ONTARIO  
RIVERS  
ALLIANCE

21 May 2021

Re: Proposed Erin Wastewater Treatment Plant  
Follow-up Commitments to the Environmental Study Report

Addendum 1

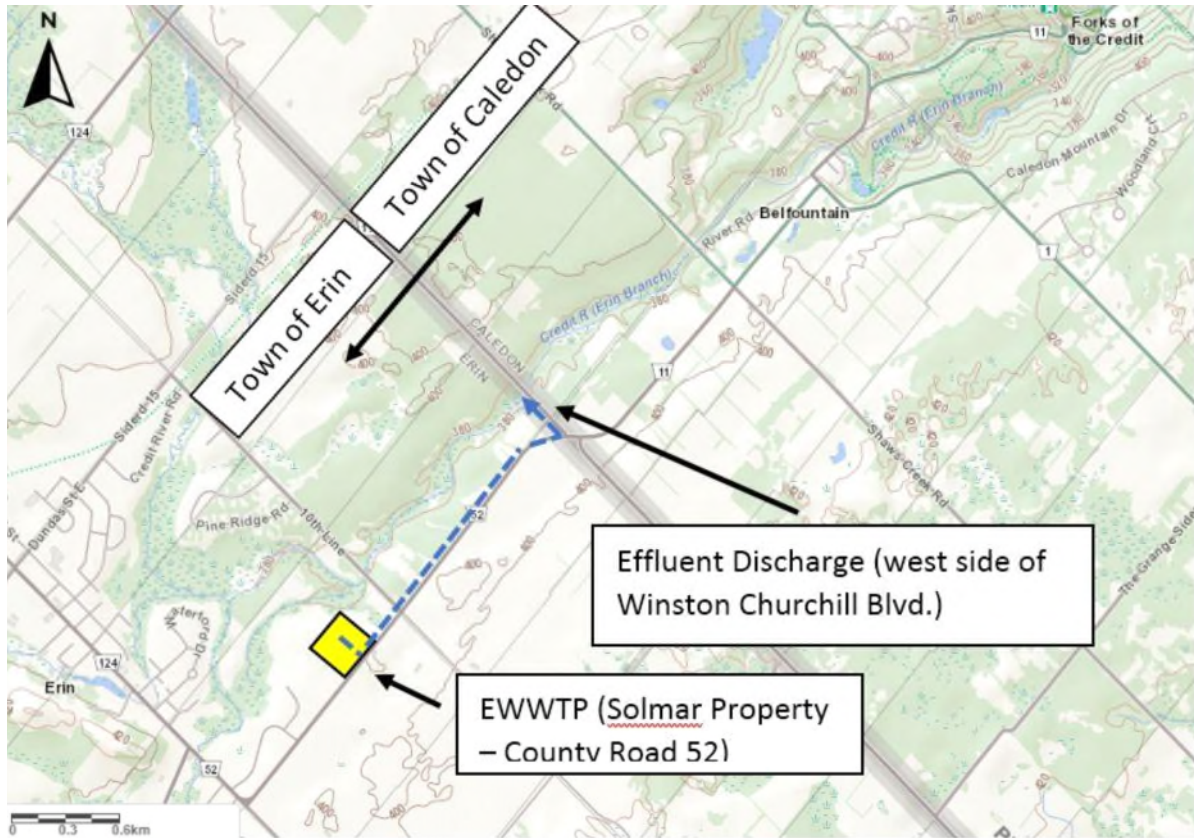
Upon selection of Site 1 (the Solmar land – Addendum 1) as the final Project site, was an Addendum to the ESR ever submitted, as committed to in the ESR?

**Erin WWTP Site Clearing**

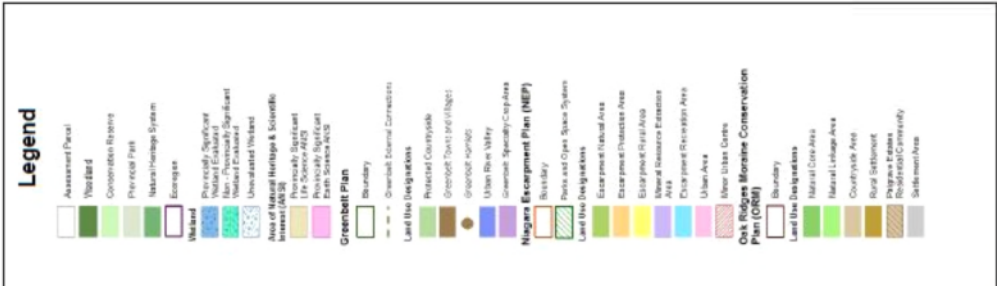
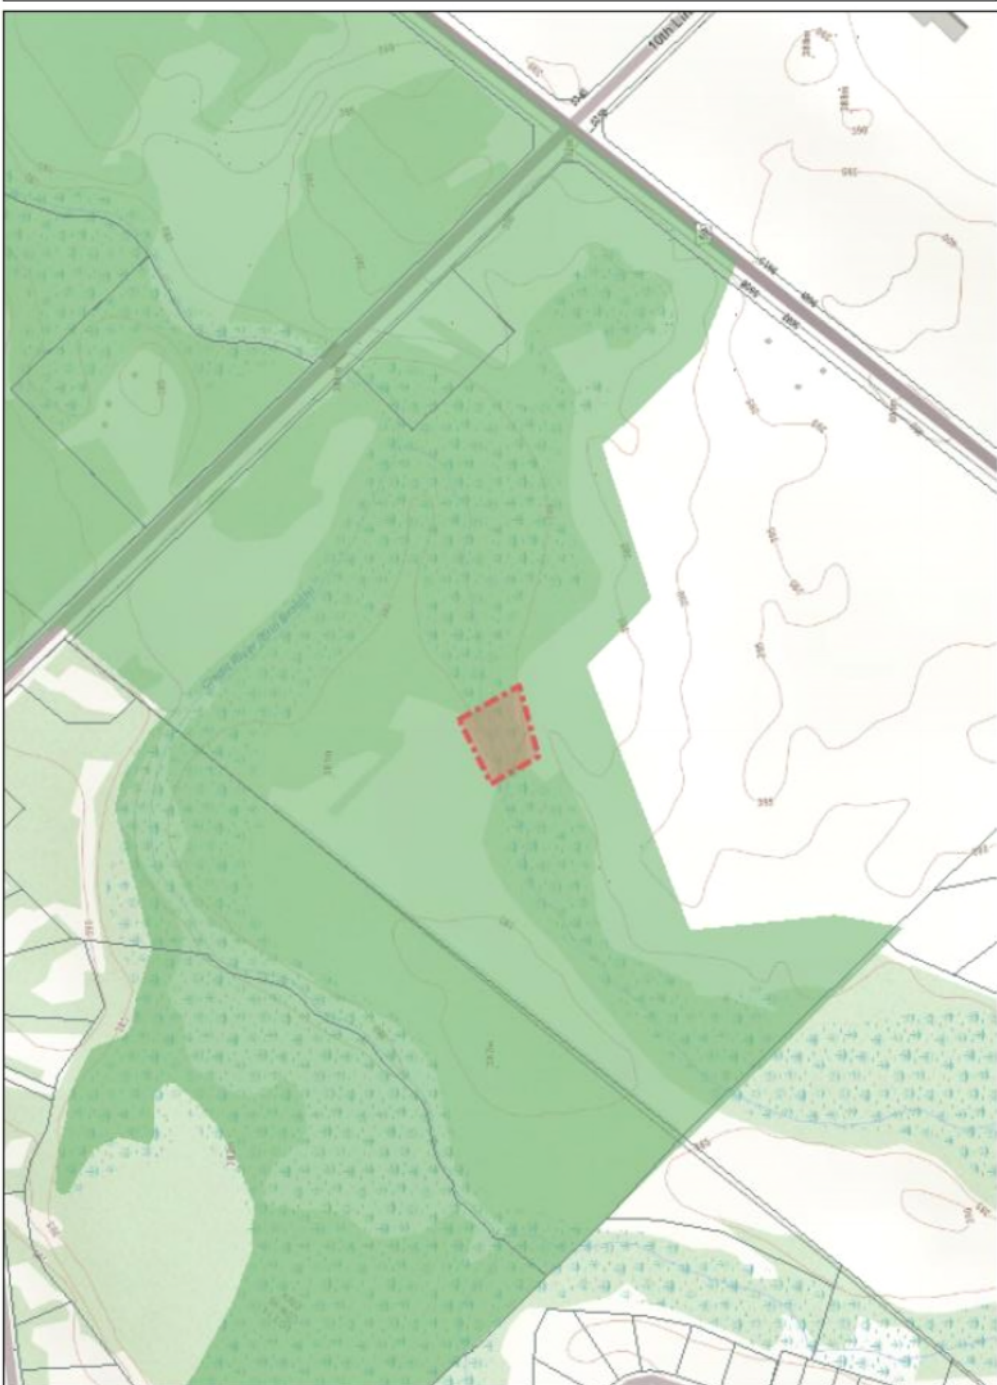
The Coalition has carefully reviewed the ESR to see what habitat related to endangered or threatened species, Schedule 1 SARA species, migratory birds or rare and uncommon plants may have been impacted by significant damage that was done on the Solmar property in late December 2020 and into the first quarter of 2021. In particular, the damage related to the premature removal of brush and trees in and around the Project site, as well as significant damage

to a first order tributary to the West Credit River in a Provincially Significant Wetland and Greenlands Natural Heritage designated area (Addendum 2). The Coalition has ascertained that there were no permits or authorizations for any of this work to take place. It is very difficult to do additional bird and tree studies when a great number of the trees and habitat were removed and burned.
